LETTER REGARDING THE ATTACHED NAVY REQUEST FOR ADDITIONAL JUSTIFICATION
FOR EPA RECOMMENDED MOVEMENT OF SOILD BORING LOCATIONS AT THE CALF
PASTURE POINT SOLVENT DISPOSAL AREA OPERABLE UNIT 8 NCBC DAVISVILE RI
8/16/2010
U S EPA REGION I

Re: *Navy request for Additional Justification for EPA Recommended Movement of Soil Boring Locations at the Calf Pasture Point Solvent Disposal Area (OU8) at the former Davisville Naval Construction Battalion Center, North Kingstown, RI*

Technical Memorandum
Relocation of Source Area Investigation Soil Borings

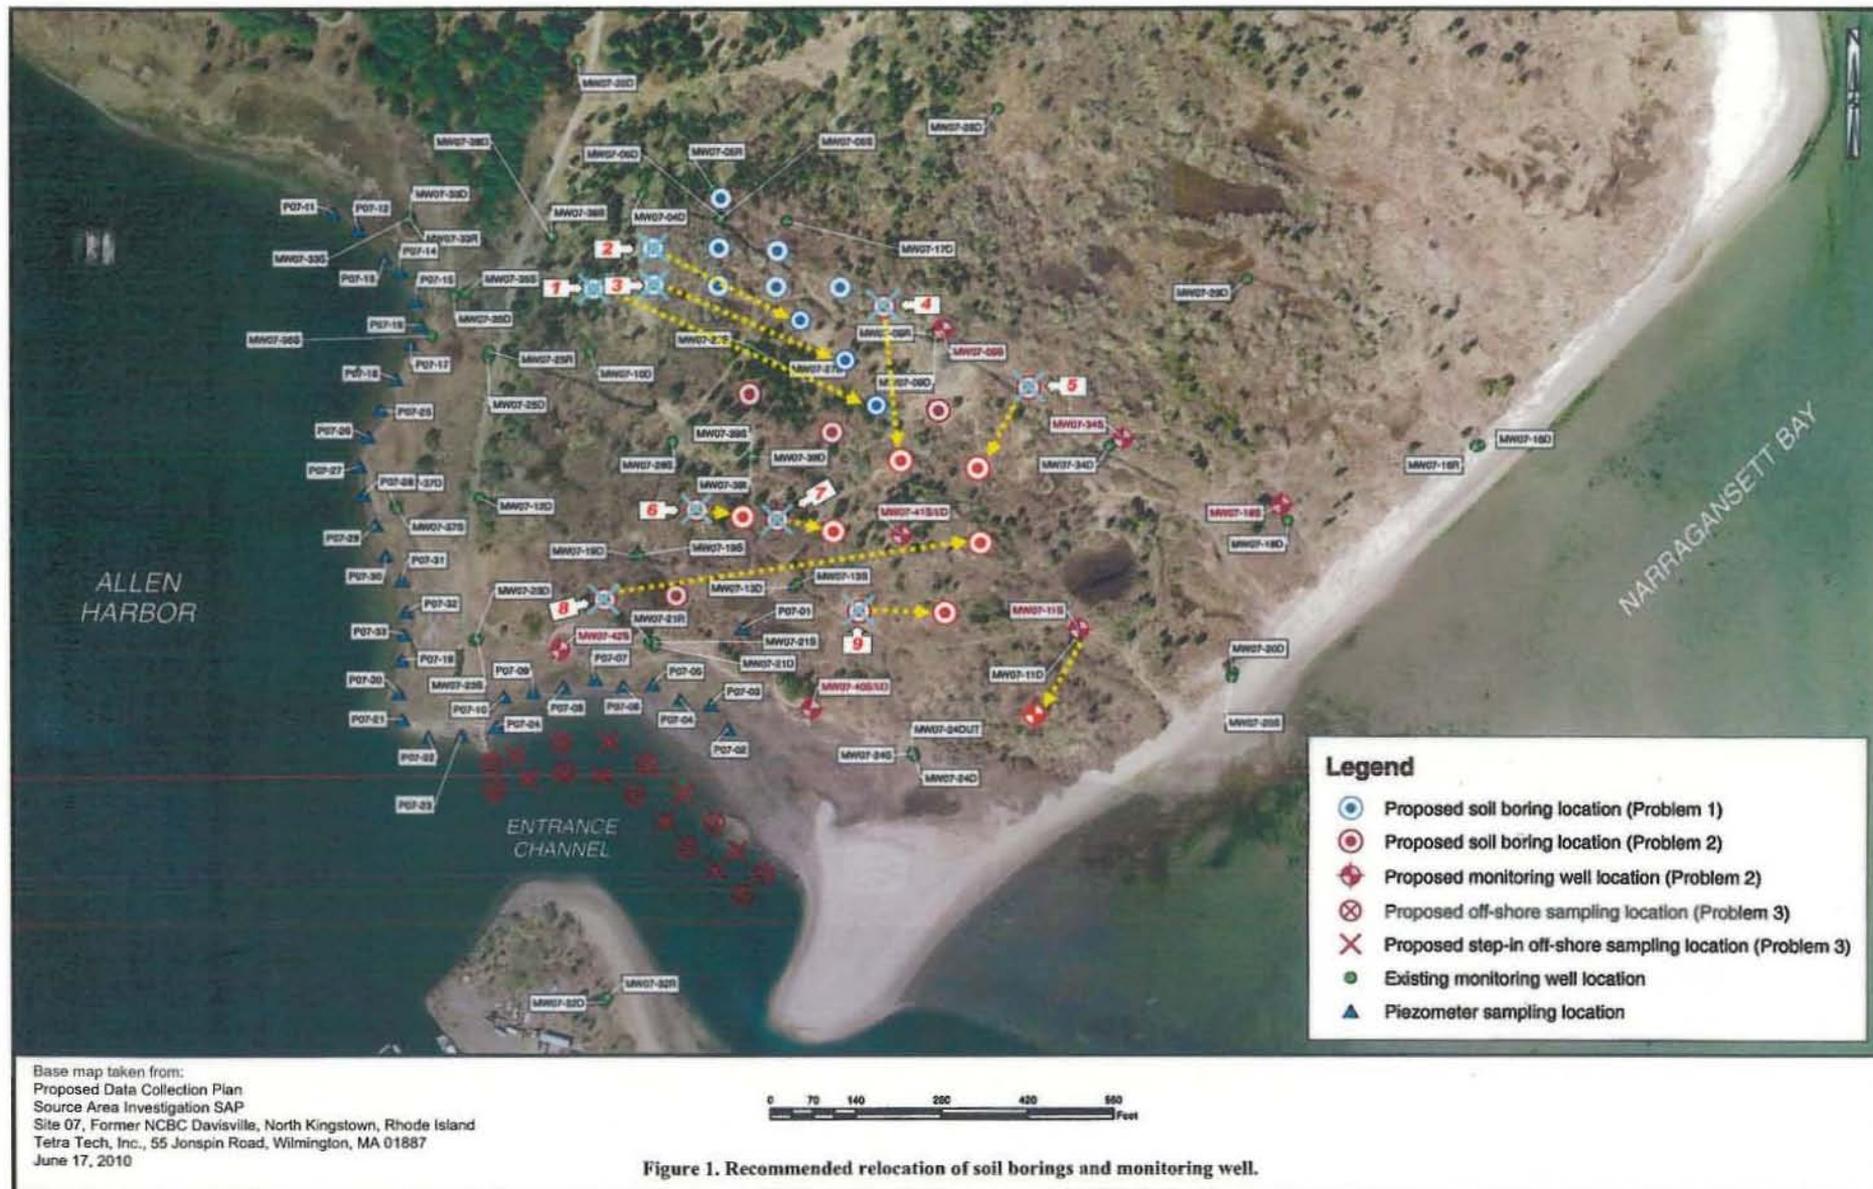
The following table provides rational for the recommended relocation of several of the planned soil borings identified in the Navy Site 07 Source Area Investigation Work Plan Sheets. The recommended soil borings for relocation are numbered with the current and recommended relocations shown on the attached figure. The recommended relocations are based upon several factors. These include analysis of preferential groundwater flow paths, historic concentrations and trends in chlorinated volatile organic compounds (CVOC), and estimated contaminant migration velocities as presented in the USEPA Updated Conceptual Site Model (CSM). They are also based upon analysis of the Battelle CVOC Mass Estimate Report. That report indicates that the center of CVOC mass resides south of MW07-27S/D. While the location of the CVOC mass is somewhat different from that estimated by USEPA, resulting from the Battelle estimate model weighting the mass more to the west due to a lower density of data to the east for the data set, it nonetheless, corresponds to the USEPA estimate for the dissolved plume center of mass to be further to the southeast than is presently assumed in the Navy Source Area Investigation Plan. The objective of the proposed relocations of Problem One and Problem Two soil borings as well as MW07-11S is to provide more coverage along the preferential down gradient groundwater flow path from the Inferred Source Area.

Soil Boring – Monitoring Well Designation	Rational
Problem One Soil Boring (Blue) #1	Preferential groundwater flow path is toward the southeast. Battelle and EPA Updated CSM indicate CVOC center of mass south of MW07-27S/D. Analytical data does not indicate significant CVOC mass at the west end of the Problem One Soil Boring Grid. Recommended location is along the axis of preferential GW flow.
Problem One Soil Boring (Blue) #2	Preferential groundwater flow path is toward the southeast. Battelle and EPA Updated CSM indicate CVOC center of mass south of MW07-27S/D. Analytical data does not indicate significant CVOC mass at the west end of the Problem One Soil Boring Grid. Recommended location is along the axis of preferential GW flow.
Problem One Soil Boring (Blue) #3	Preferential groundwater flow path is toward the southeast. Battelle and EPA Updated CSM indicate CVOC center of mass south of MW07-27S/D. Analytical data does not indicate significant CVOC mass at the west end of the Problem One Soil Boring Grid. Recommended location is along the axis of preferential GW flow.

Problem Two Soil Boring (Red) #4	Current location is redundant with data that will be obtained from the soil boring and groundwater for MW07-09S. The proposed relocation further to the south will augment coverage along the axis of preferential groundwater

flow to the southeast along with the proposed relocation of the three Problem One soil borings.
Problem Two Soil Boring (Red) #5	Current location is redundant with data that will be obtained from the soil boring and groundwater for MW07-34S. The proposed relocation further to the southwest will augment coverage along the axis of preferential groundwater flow to the southeast along with the proposed relocation of the three Problem One soil borings.
Problem Two Soil Boring (Red) #6	Current location is likely off axis to the west based on analysis of groundwater flow and cyclical patterns of CVOC observed in MW07-39D. Shifting the location approximately 100 feet to the east will place the soil boring in a more suitable location to intercept contaminated groundwater flowing past MW07-39.
Problem Two Soil Boring (Red) #7	Current location is likely off axis to the west based on analysis of groundwater flow and cyclical patterns of CVOC observed in MW07-39D. Shifting the location approximately 100 feet to the east will place the soil boring in a more suitable location to intercept contaminated groundwater flowing past MW07-39.

Problem Two Soil Boring (Red) #8	One soil boring as well as existing monitoring wells provides reasonable coverage along the southwest groundwater flow path. The proposed relocation of this soil boring to the east of the planned MW07-41 will augment down coverage of the down gradient aquifer along with relocation of the soil borings above.
Problem Two Soil Boring (Red) #9	Groundwater flow paths appear to be diverted to the west and east of MW07-13S/D. Also, groundwater flowing to the south of the SAP location will be intercepted by the planned MW07-40. Shifting this soil boring to the east will fill in a gap in coverage along the primary groundwater flow path from the Inferred Source Area.
MW07-11S	Relocate this monitoring well to southwest approximately midway between MW07-11D and MW07-24S. Analysis indicates wetlands may intercept/divert shallow groundwater. Also, the general trend of deep overburden groundwater (no shallow data available) suggests shallow groundwater also flows to this location.

While the Battelle and USEPA Updated CSM indicate that the CVOC center of mass is past the location of MW07-27S/D the actual location may be somewhat further to the southeast than is presently estimated. Currently, there is an absence of data in the central area of Site 07, including hydraulic conductivity and total organic carbon content of aquifer materials, such that contaminant migration velocity in that down gradient area cannot be precisely estimated. The above recommendations are intended to maximize assessment of potential CVOC in soils in the down gradient locations from the Inferred Source Area with the available resources in order to assess the need/viability of a dissolved source remediation.
